BOCA GRANDE HISTORIC PRESERVATION BOARD

SPECIAL CERTIFICATE OF APPROPRIATENESS SCA2018-10018 DECISION

Designation No.: HD 90-05-01
Name of Project: 7th St Boathouse and Marina
Location: 789 7th St West, Boca Grande, FL 33921
Strap No.: 14-43-20-01-00057.0250
Name of Agent: Brad Wester
E-Mail: rhawthorne@drivermcafee.com

Request: Demolish the existing boathouse and construct new a two-story boathouse in its place.

SOUTH ELEVATION
FROM 7TH STREET ENTRANCE

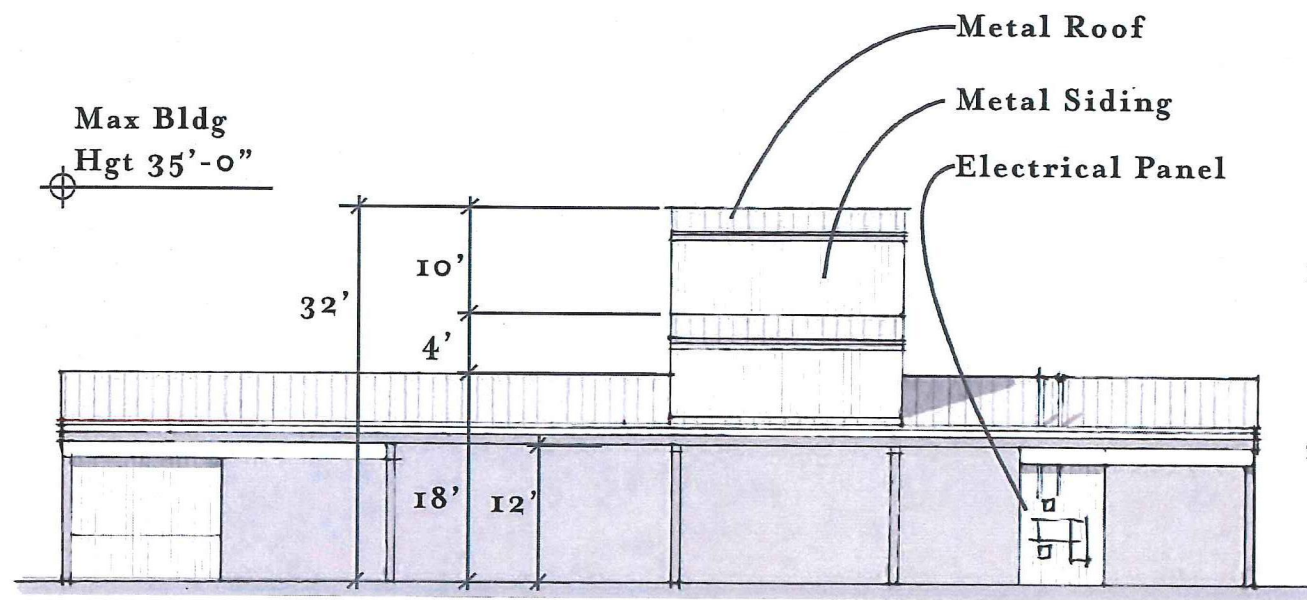
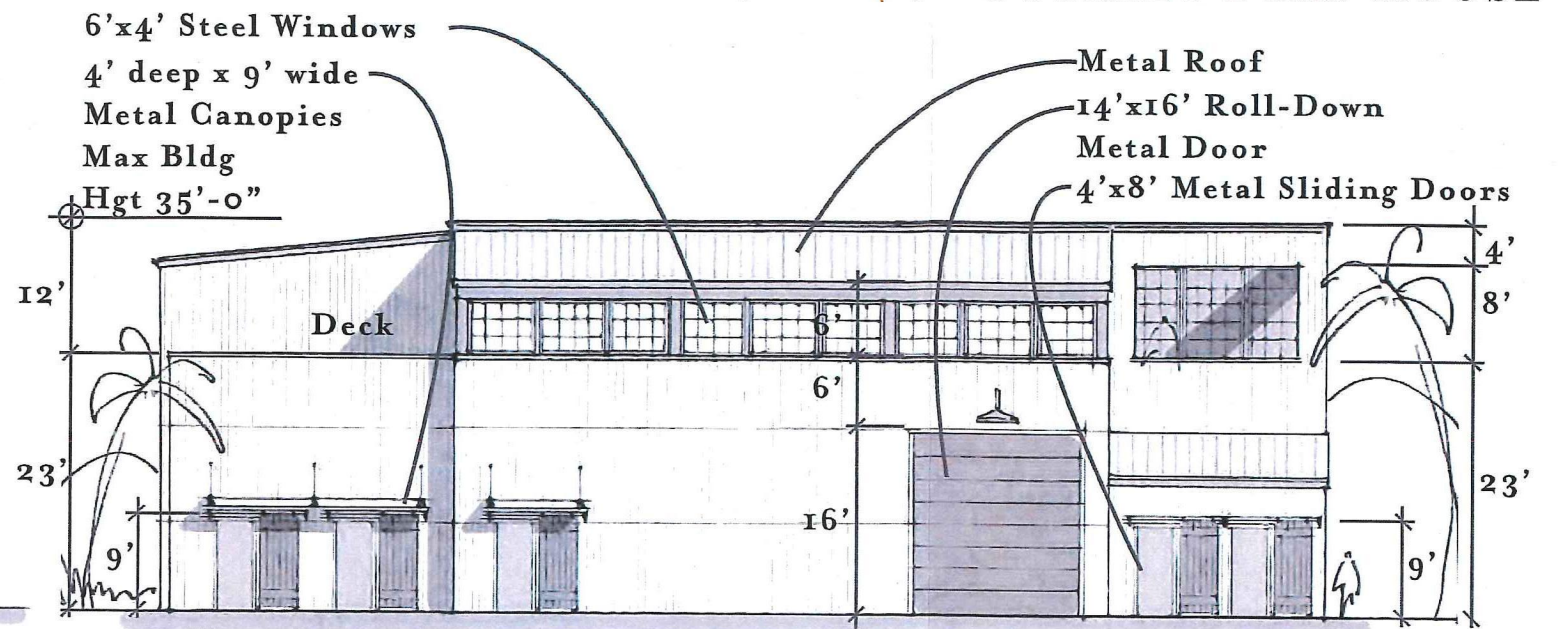
The largest feature of the front elevation is the large, 14' by 16' metal roll-down door located just off-center in the façade. There are also five metal sliding doors, three on the north side of the façade and two at the south side near the large roll-down door. These smaller doors each have a flat metal canopy. The second floor features a continuous ribbon of 4-over-3 multi-light windows running along the main section of the façade and a ribbon of three 3-over-5 multi-light windows at the south end of the building. The rest of the façade consists of metal panels typical of industrial buildings. A second floor outdoor deck is north of the flat-roofed section.

NORTH ELEVATION
FROM BOCA GRANDE BAYOU

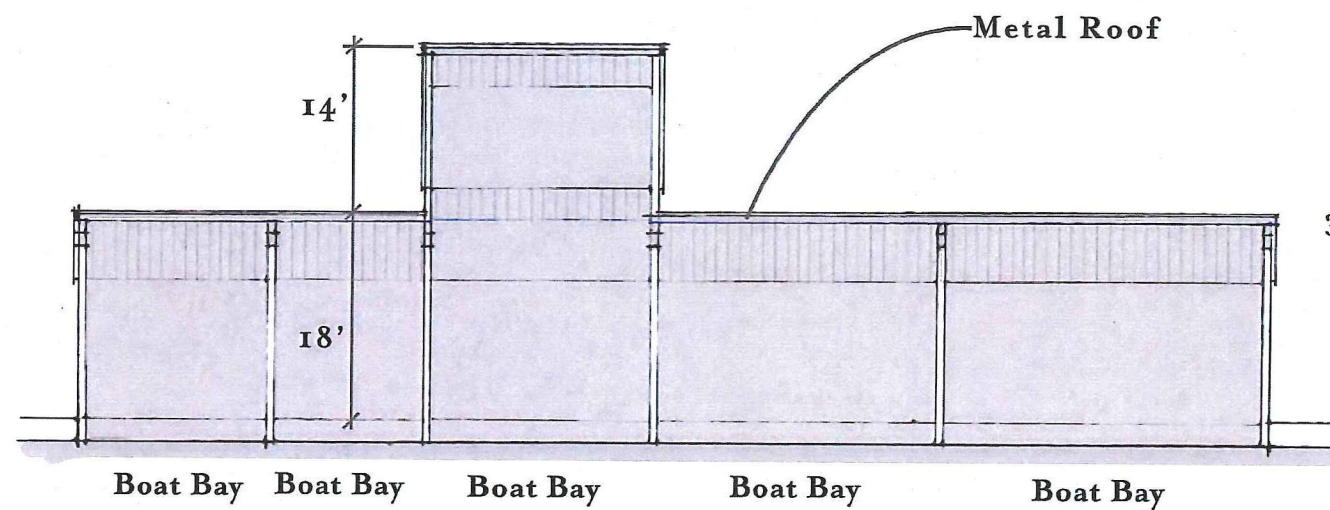
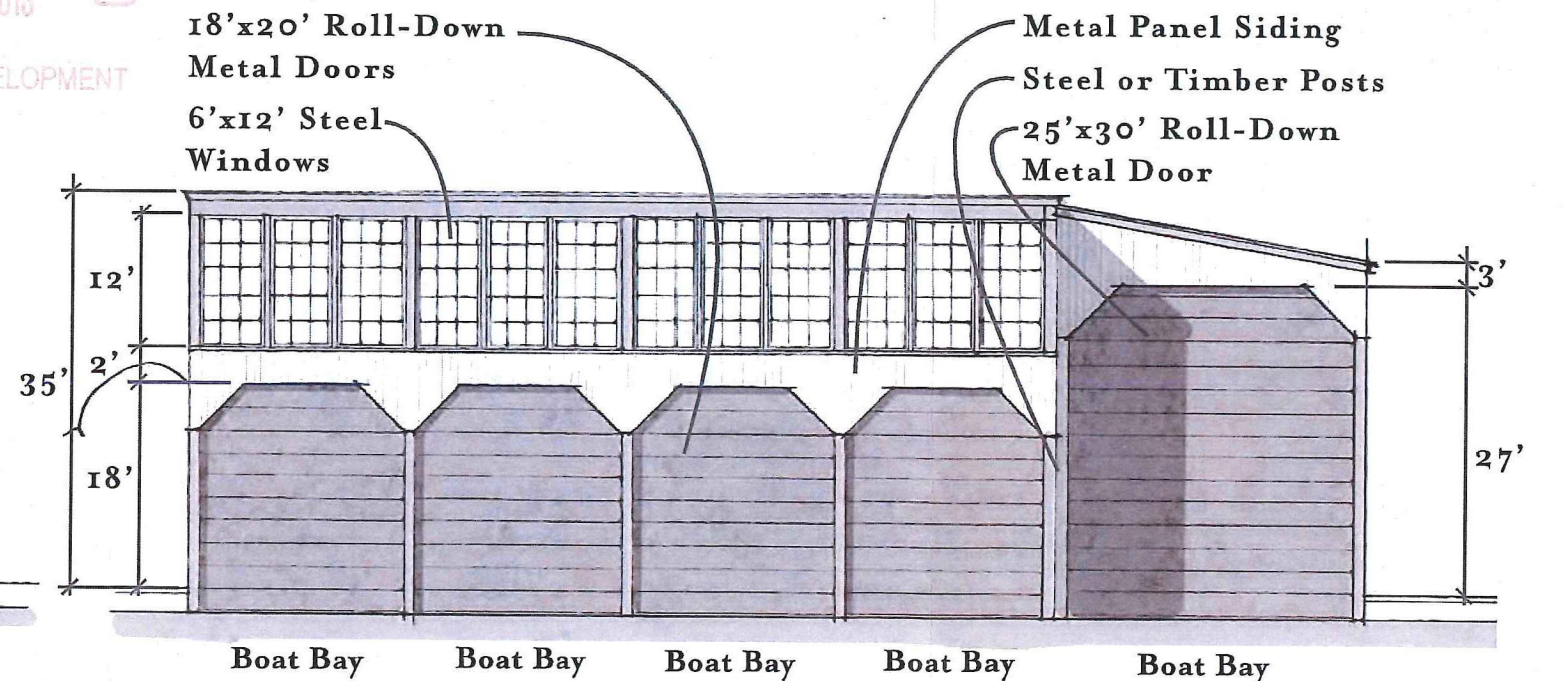
The rear elevation is dominated by the four 18' by 20' boat bay doors in the main section of the building and the 25' by 30' boat bay door under a shed roof portion on the north side. The second floor is taken up by twelve 3-over-5 multi-light windows arranged in a single continuous ribbon between the flat roof and the smaller boat doors. Metal panels fill in the small areas between the small doors and the windows and between the large door and the roof. This façade is Spartan and functional in design and as such is typical of the marine structures along Boca Grande Bayou.

WEST ELEVATION

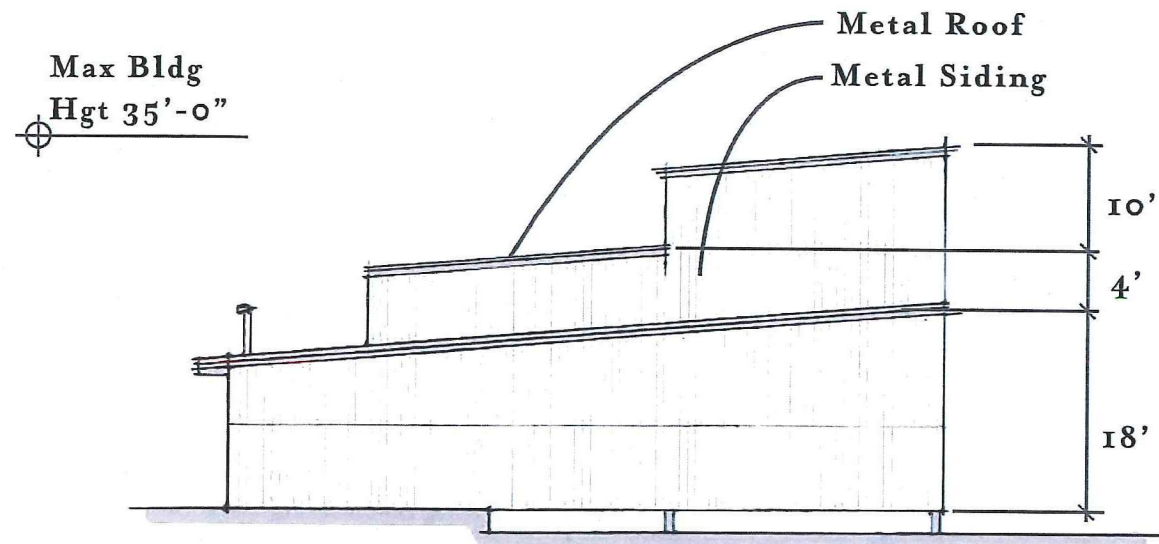
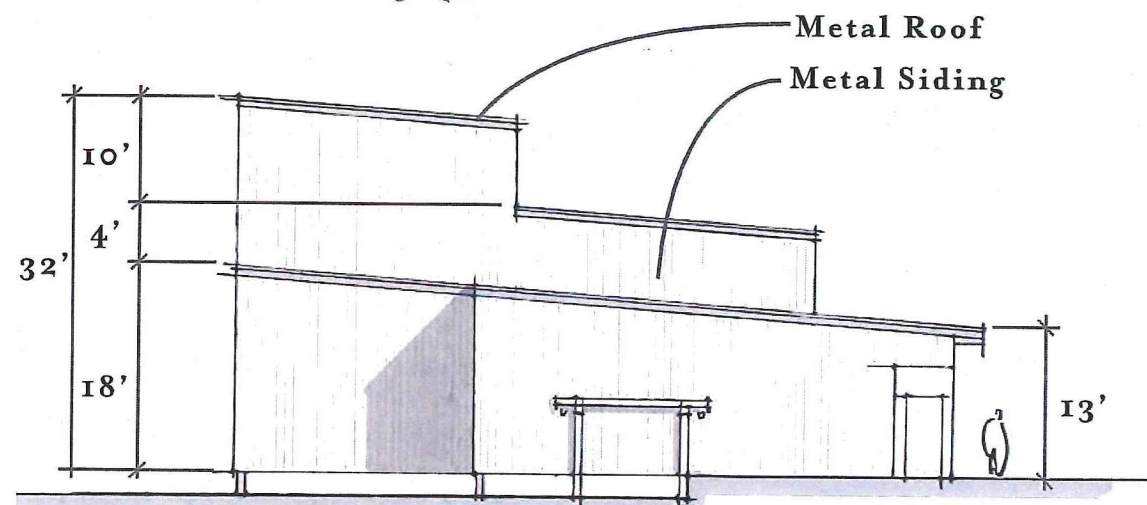
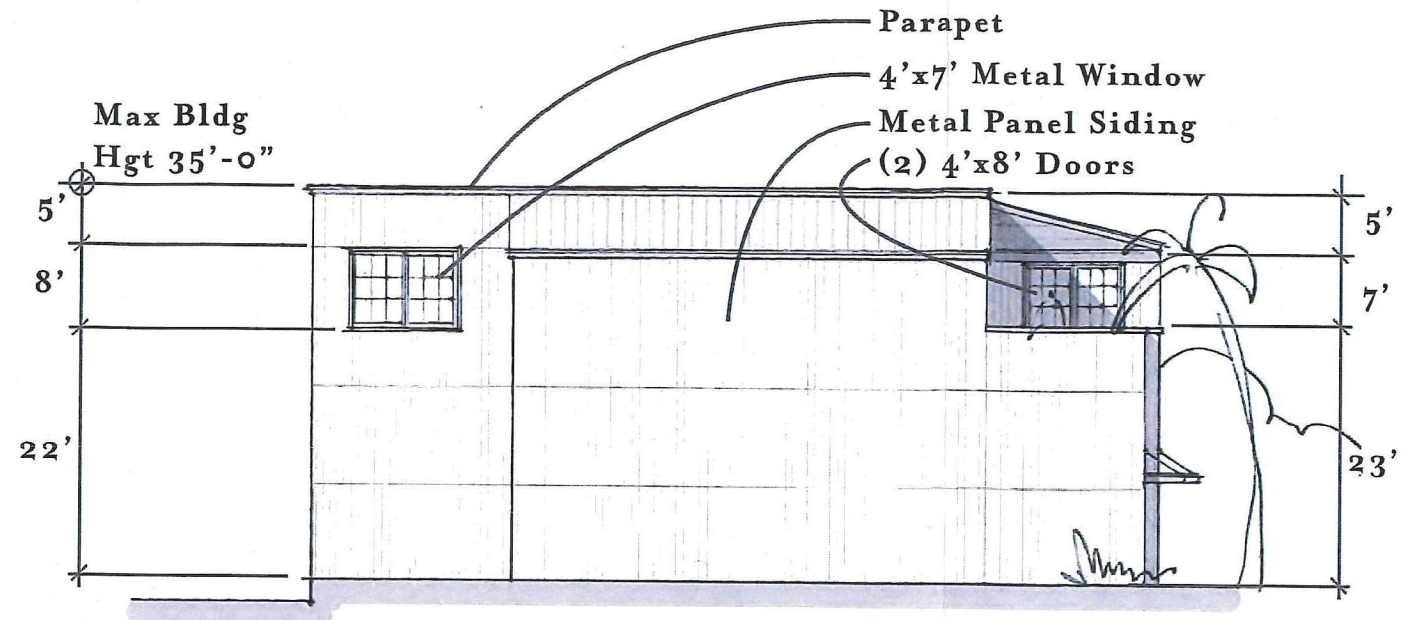
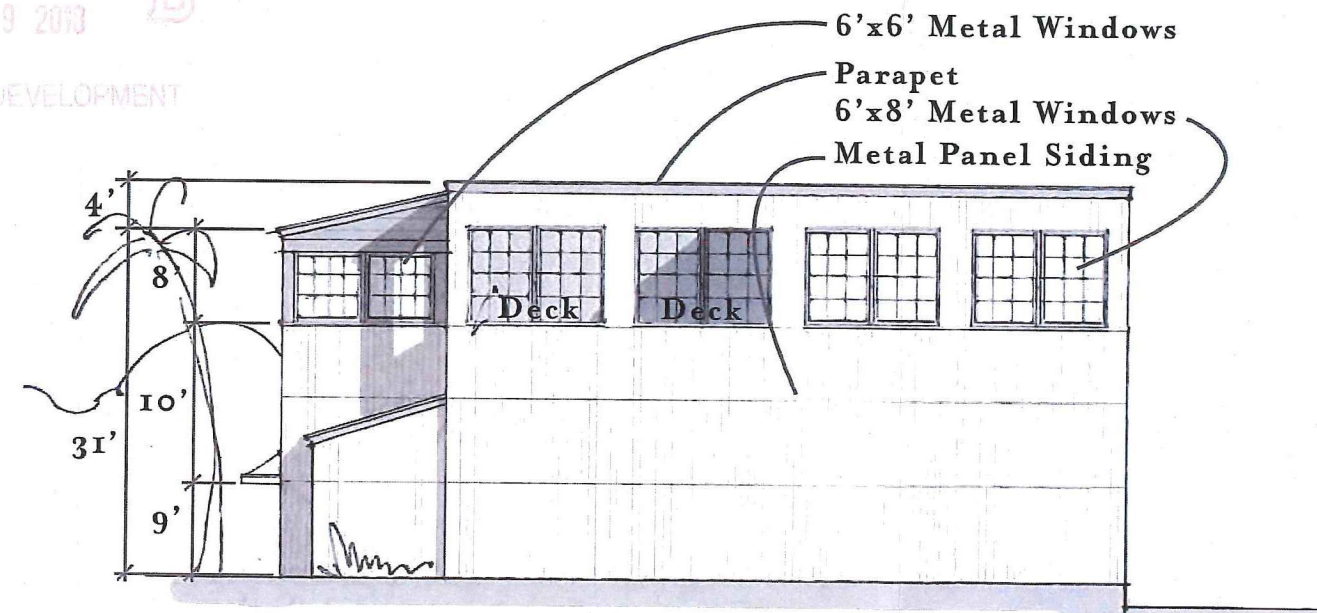
The side elevations are both mainly empty of features, showing only the metal panel walls at the ground floor. The east elevation has four pairs of 3-over-4 multi-light windows on the main section of the structure and another pair of 4-over-3 windows on the landward extension. The west elevation has four 3-over-3 multi light windows, two on the main structure and two on the landward extension. The overall appearance is typical for commercial marine buildings on the bayou waterfront.

DRAWING TITLE
SITE PLAN

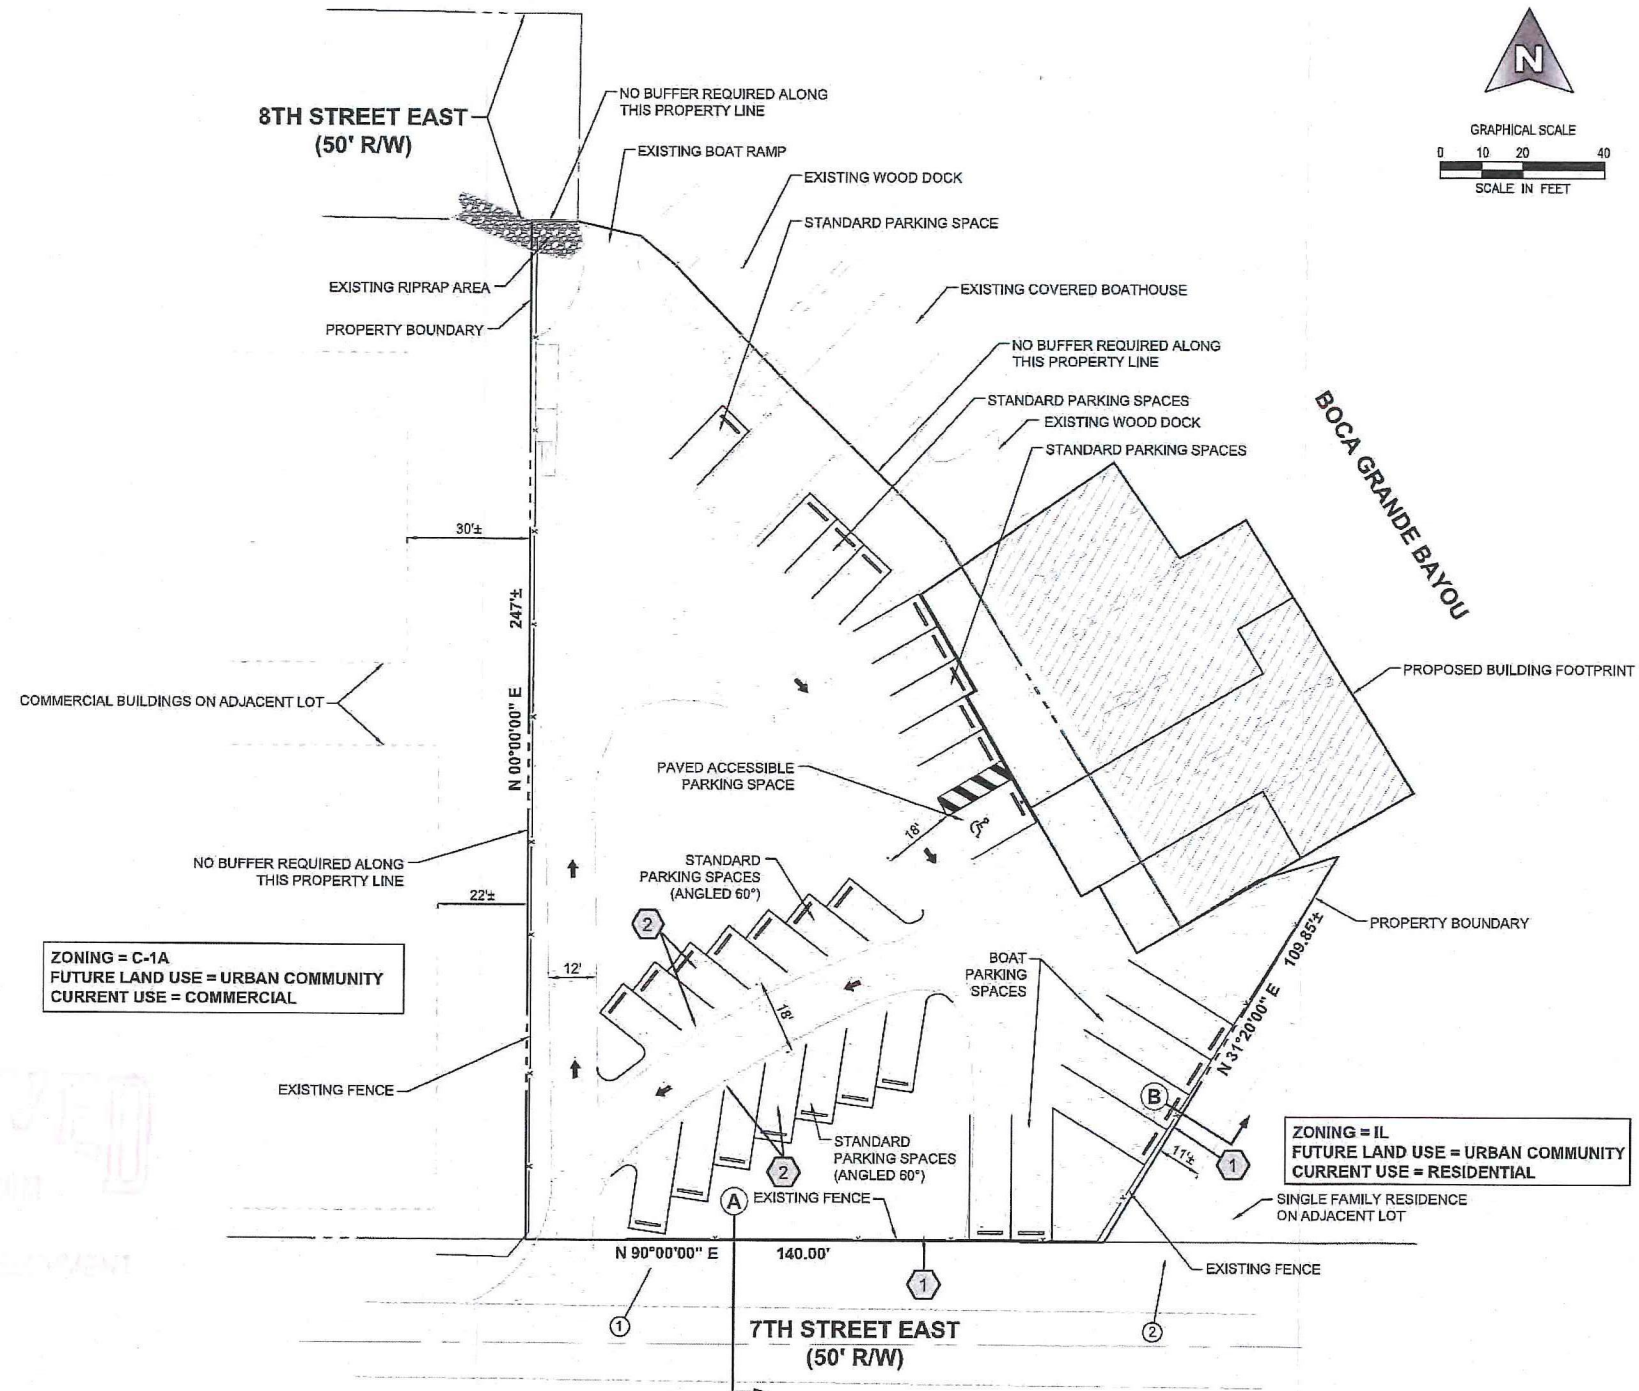
- 2.8 Paving materials and patterns should respect traditional patterns on the block.**
The existing property uses crushed shell for the parking and driving areas. The proposed paving for the driveway and parking areas will also use crushed shell. The only exception is the concrete surface for the single required ADA accessible parking space. Crushed shell conforms to the general style found within many commercial marine properties within the historic district and the community as a whole.

- 2.9 Landscaping should respect traditional planting patterns and maintain the alignment, spacing, and type where possible.**
The proposed site will maintain the current distribution of grassy areas and vegetated spaces on the south and southeast as depicted in the site plan.
